PRODUCT ADVISORY

Data Sheet Specification Correction for Intersil ZL6105ALAF* Products

**Refer to:
PA12097**

Old POD L36.6x6A – PA12097

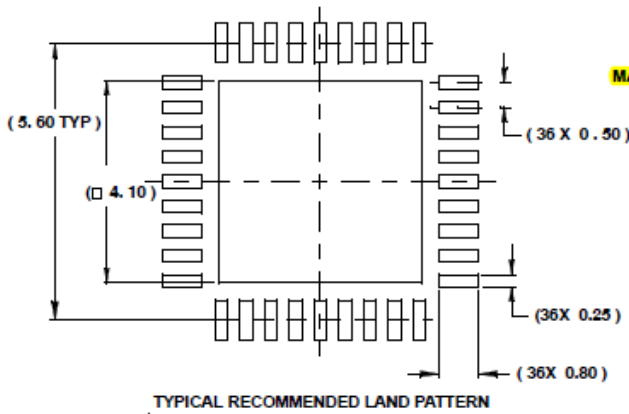
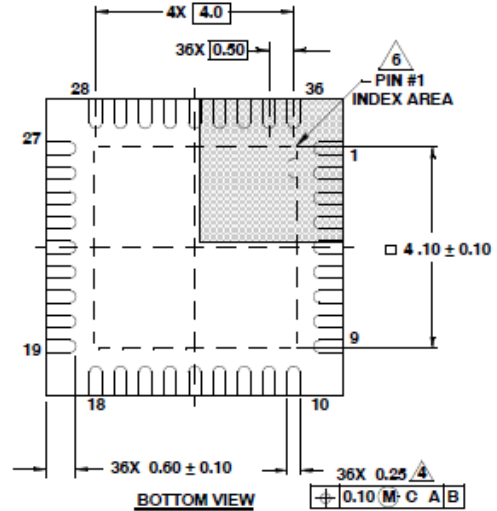
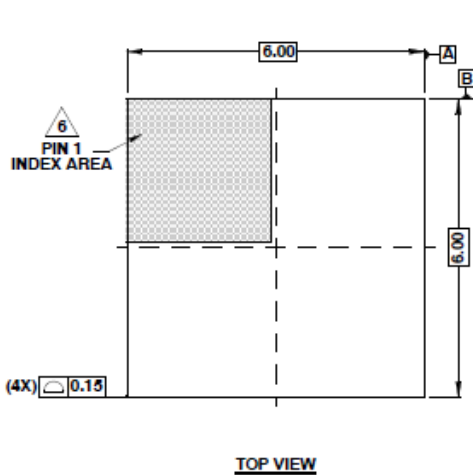
This advisory is to inform you that Intersil has made corrections to the POD (Package Outline Drawing) referenced in the data sheet specification for the ZL6105ALAF* products. The updates to the POD correct the thickness (height) of the package body. The old and new PODs are contained on following pages. There have been no changes to the package or product itself. The updated data sheet is available on the Intersil web site at <http://www.intersil.com/content/dam/Intersil/documents/fn69/fn6906.pdf>.
